# Syar Alexander Valley Instream Mining Project and Sonoma County ARM Plan Amendments

## Response to Comments Document

SCH# 2006042101

Prepared for  
County of Sonoma Permit  
and Resource Management Department

**Figure 3.6-4**  
**Syar Alexander Valley**  
**In-Stream Mining Cumulative With Project**  
**AM(PM) Volumes**

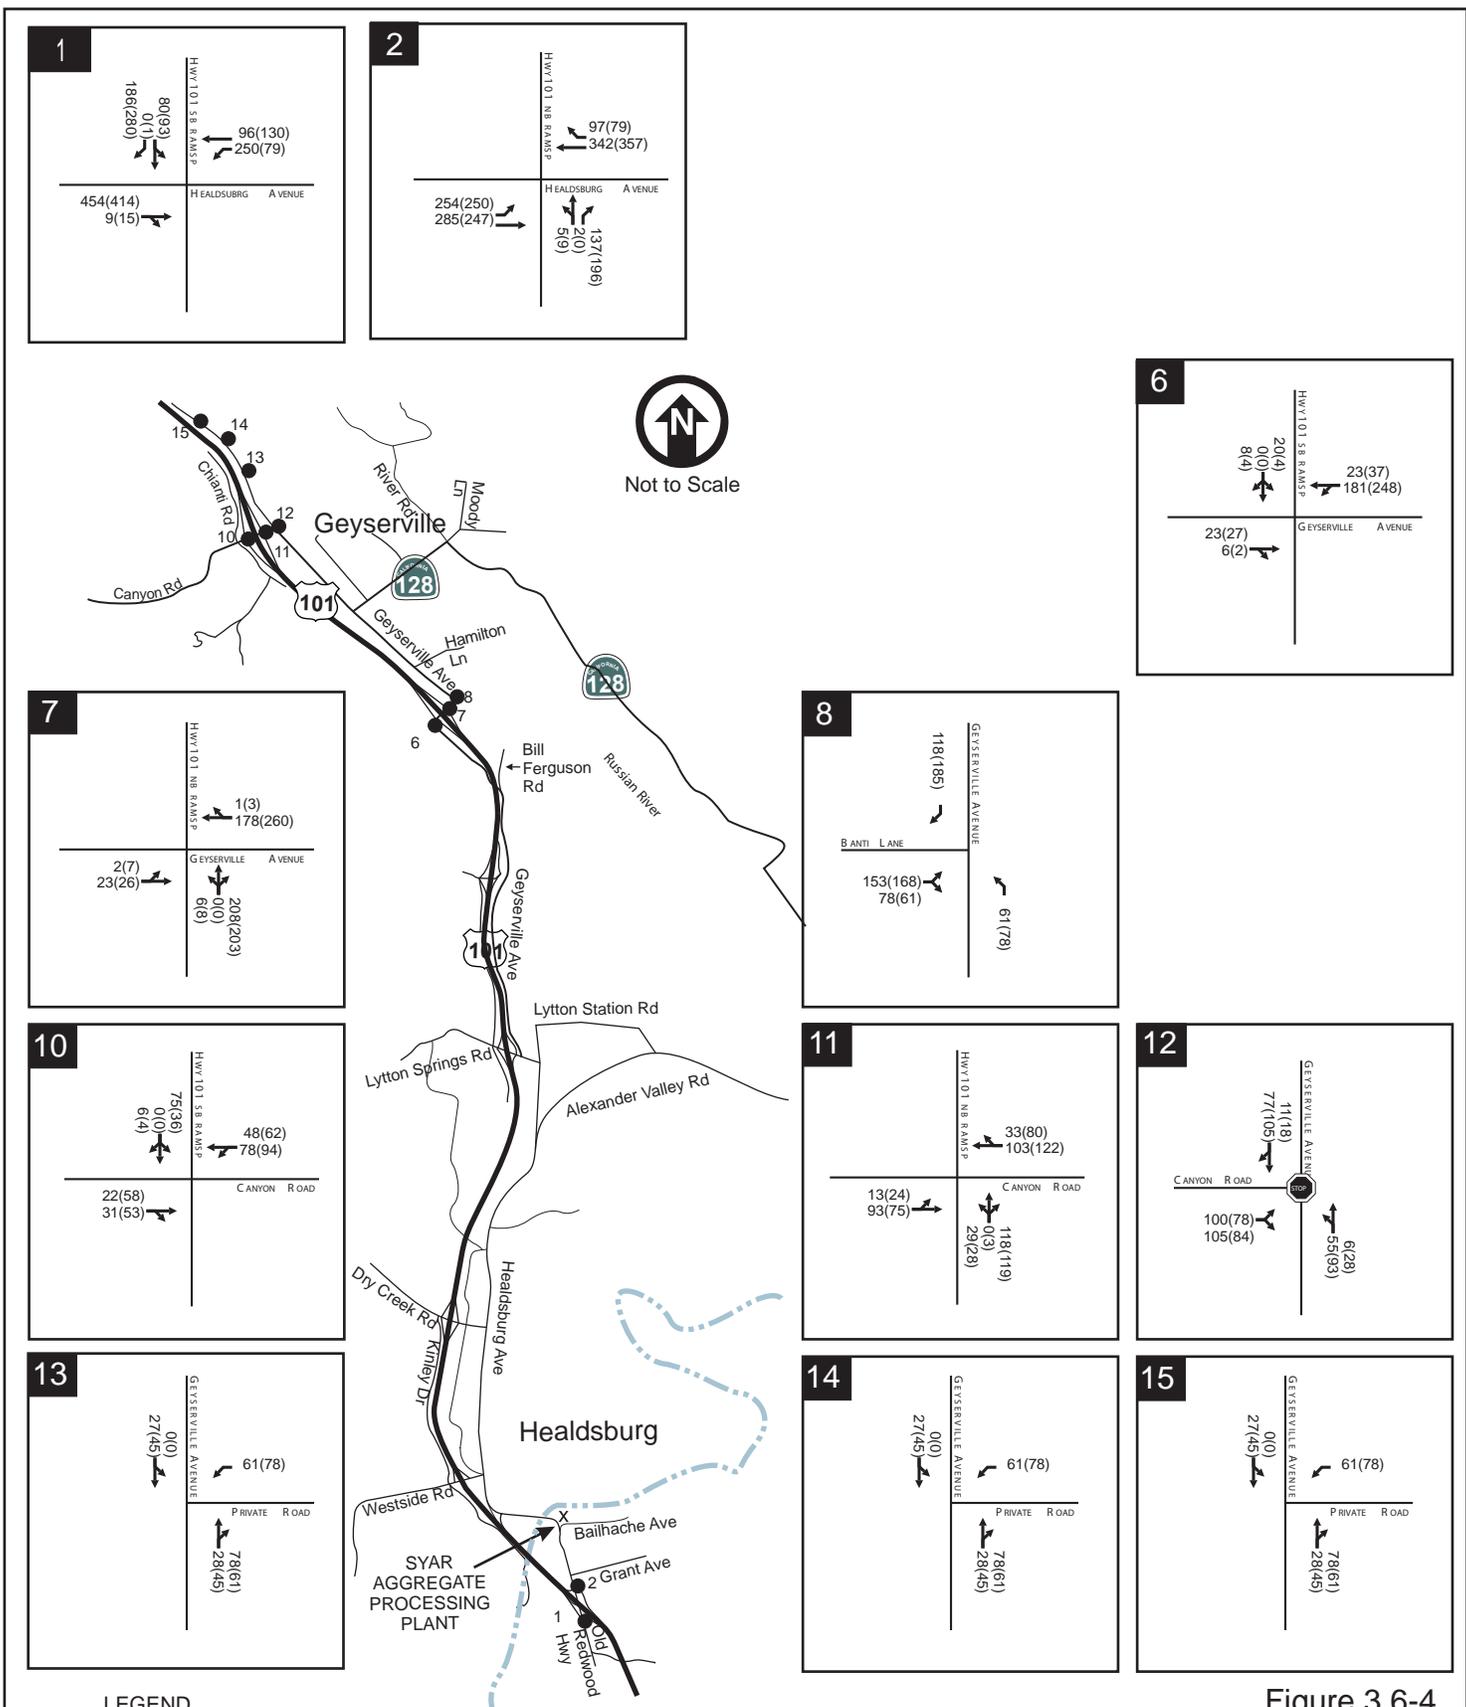
Page 3.6-21 of the Draft EIR, Figure 3.6-4 is revised to reflect the elimination of Haul Routes 2 and 5 from the proposed project.

**Figure 3.7-2**  
**Sensitive Receptor Locations: Reach 2**

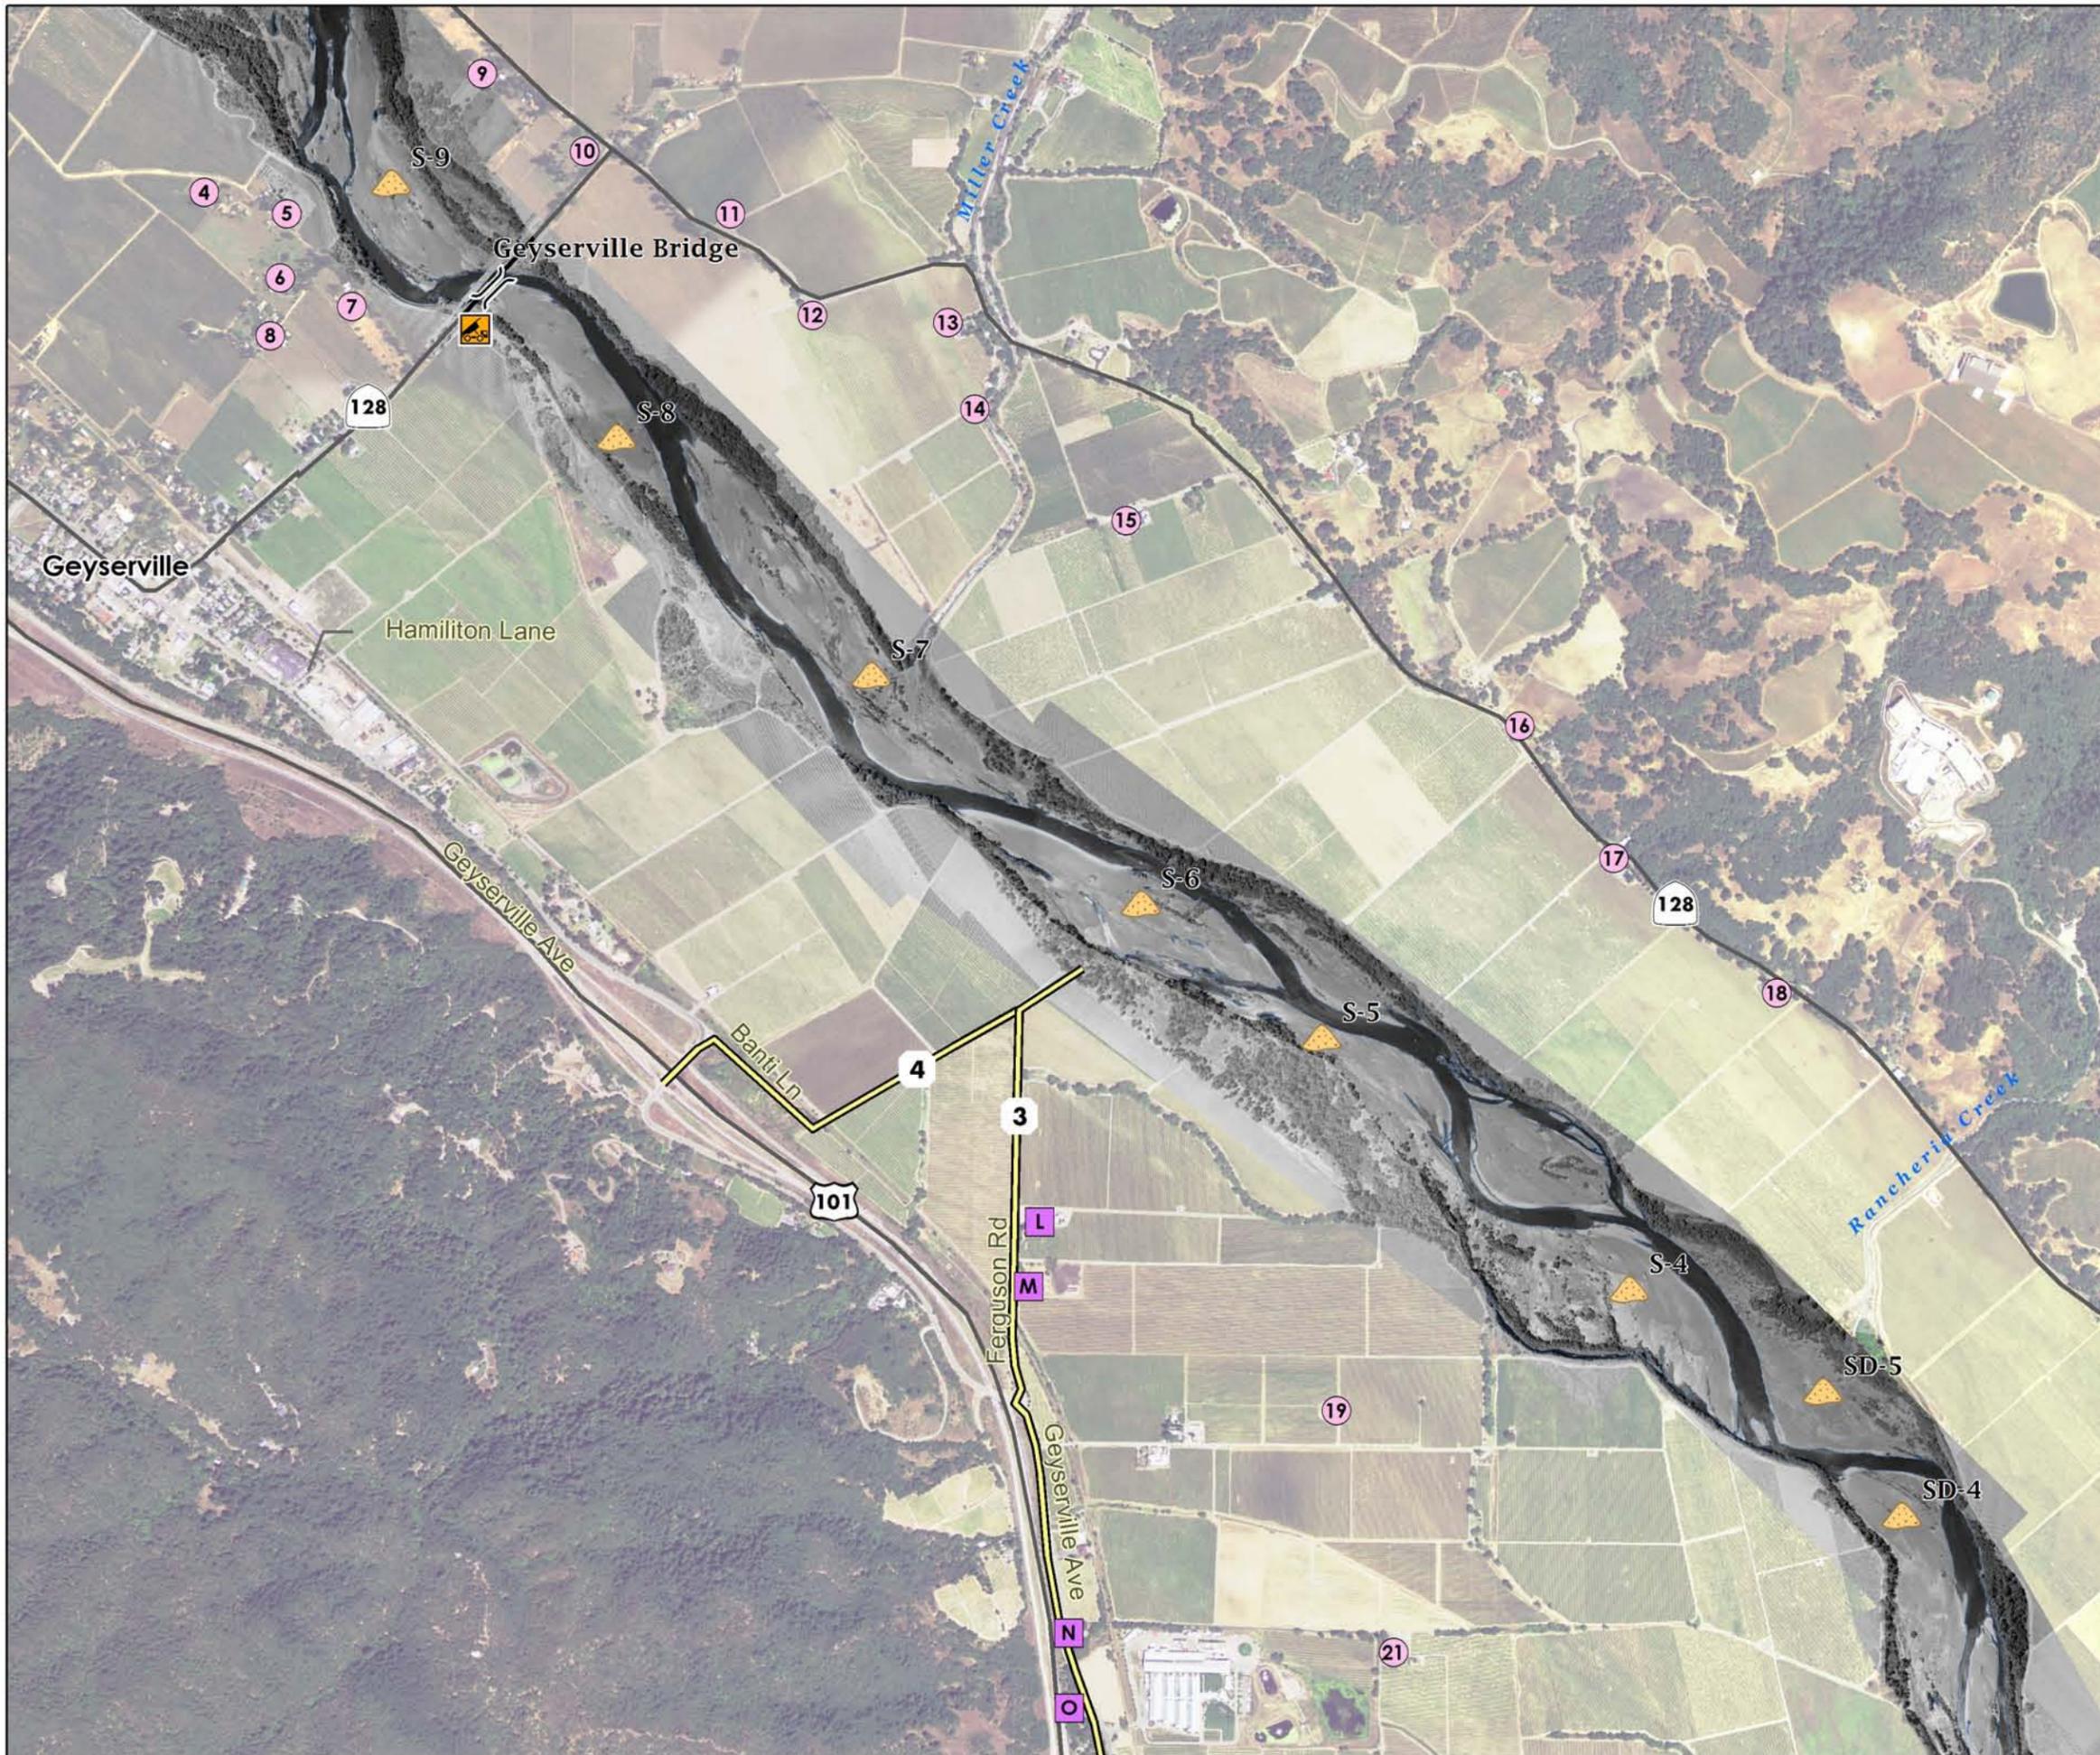
Page 3.7-29 of the Draft EIR, Figure 3.7-2 is revised to reflect the elimination of Haul Routes 2 and 5 from the proposed project.

**Figure 3.7-3**  
**Sensitive Receptor Locations: Reach 3**

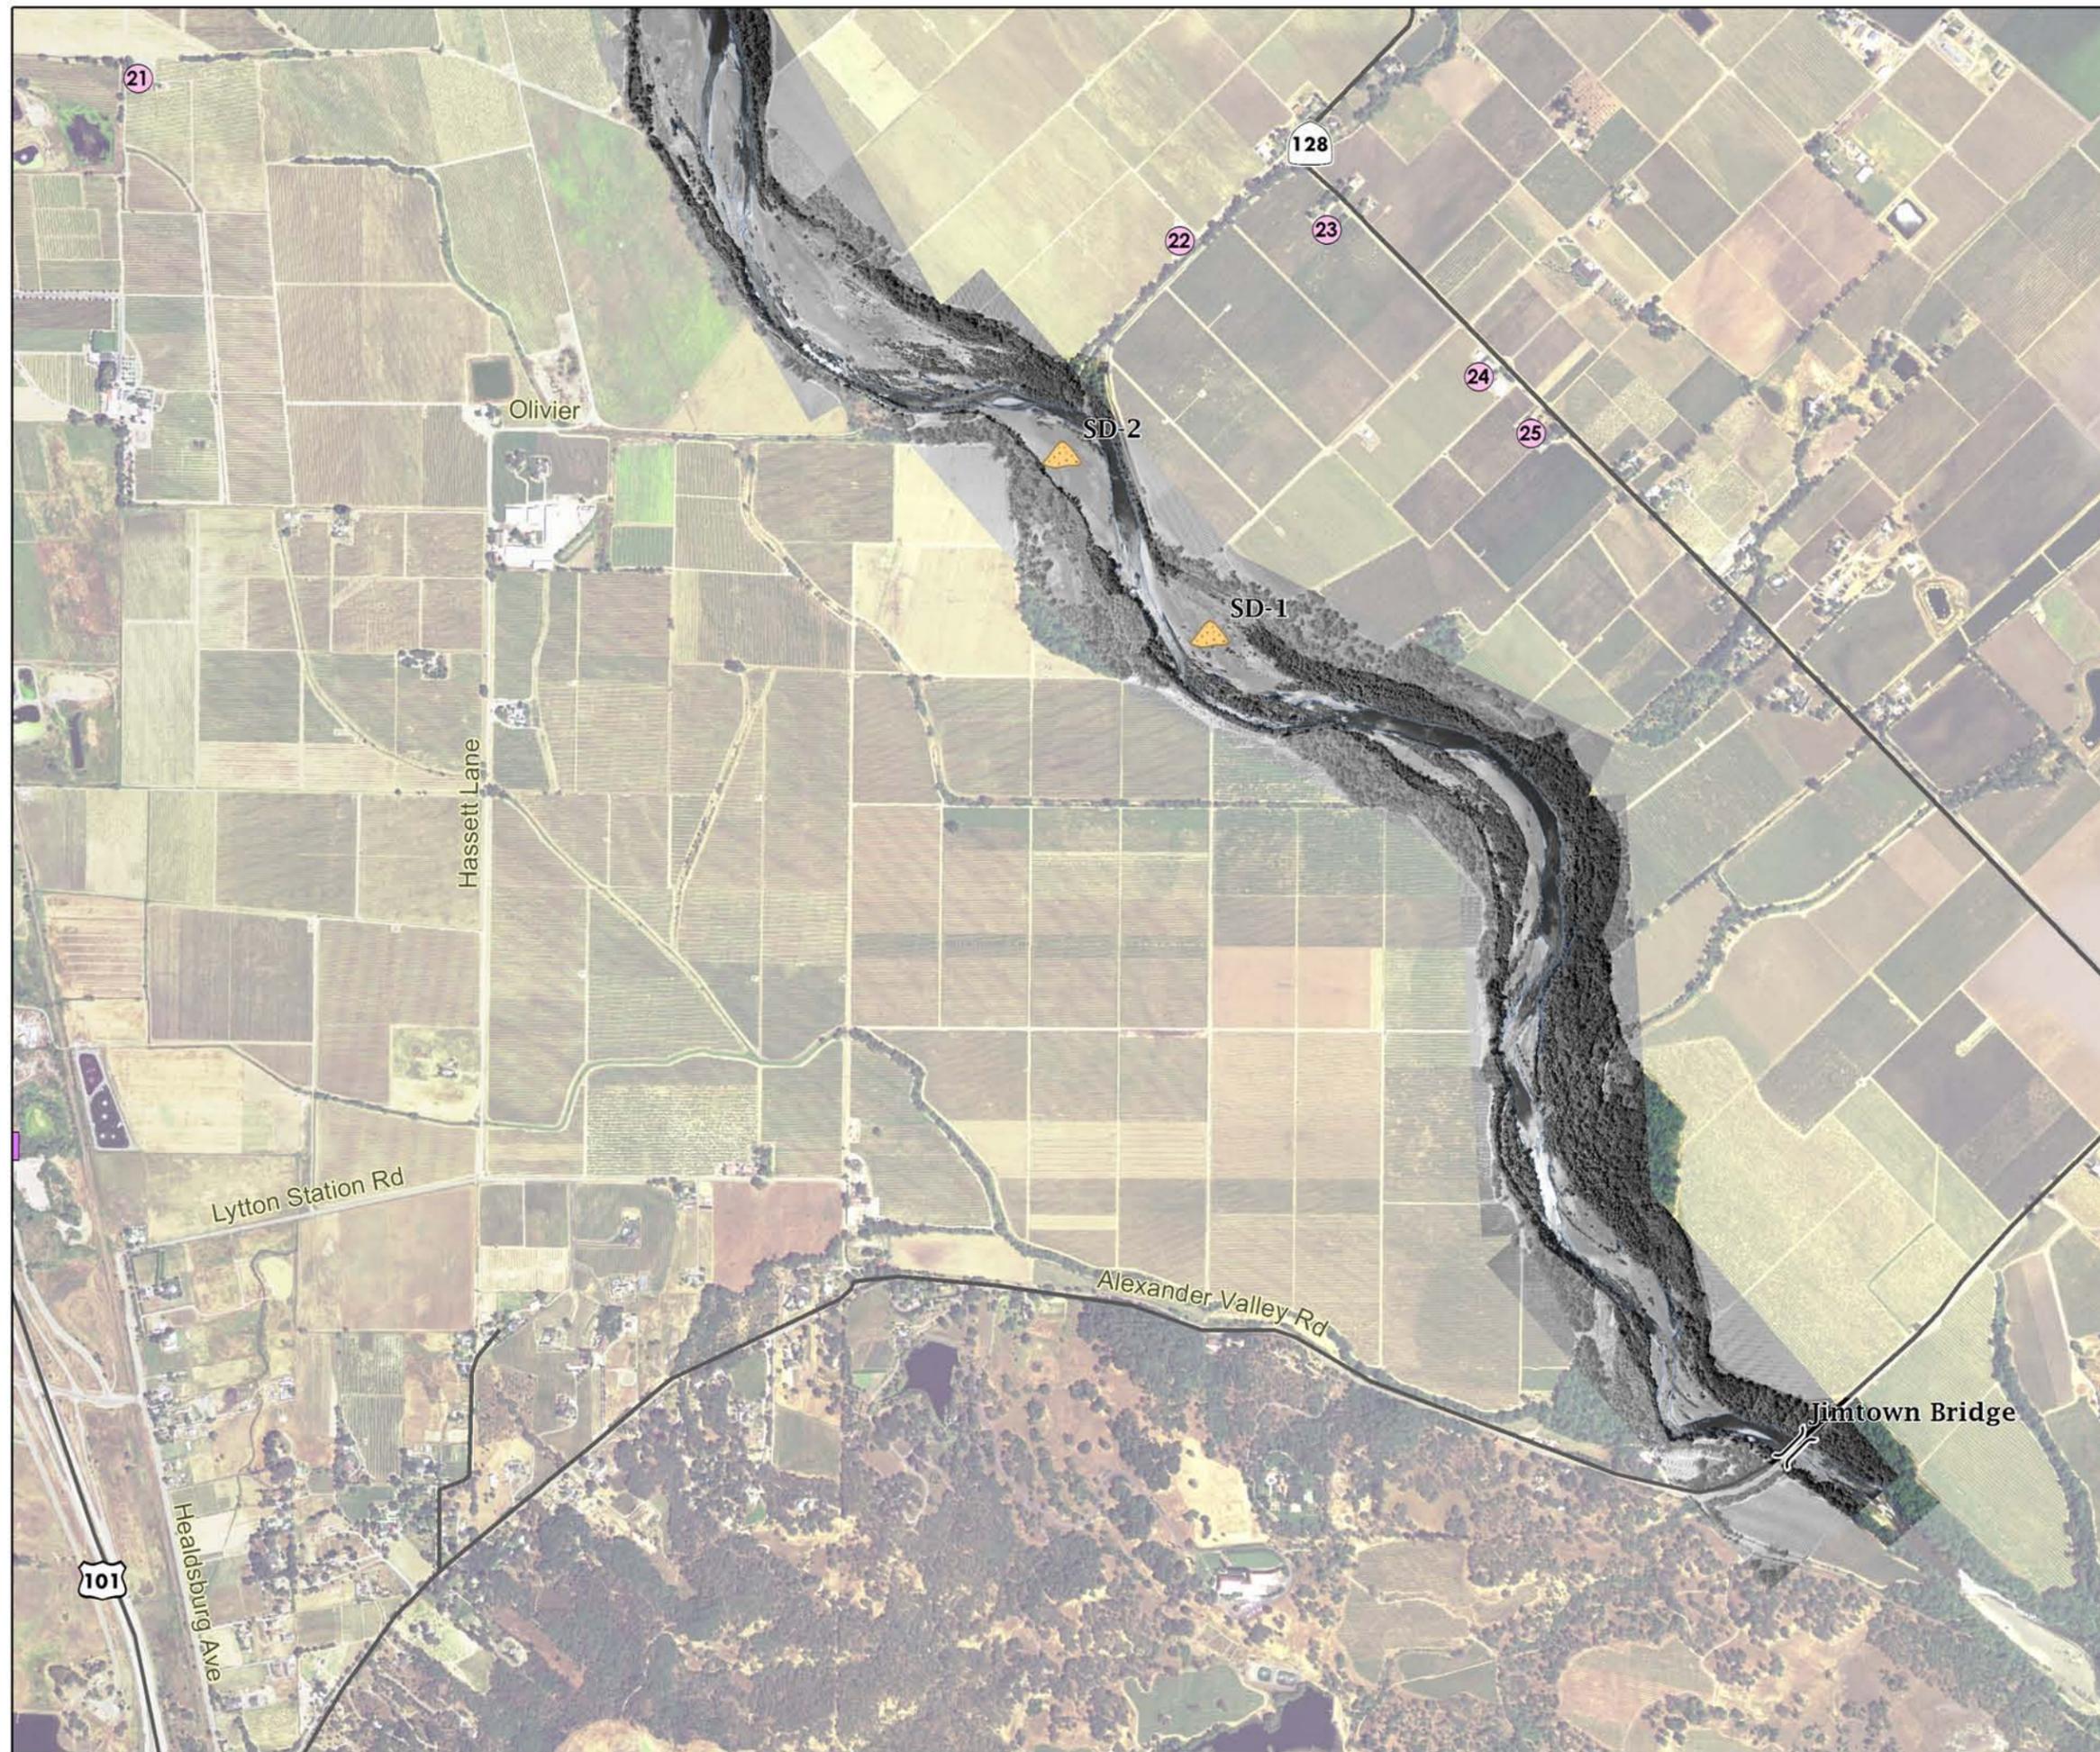
Page 3.7-31 of the Draft EIR, Figure 3.7-3 is revised to reflect the elimination of Haul Routes 2 and 5 from the proposed project.
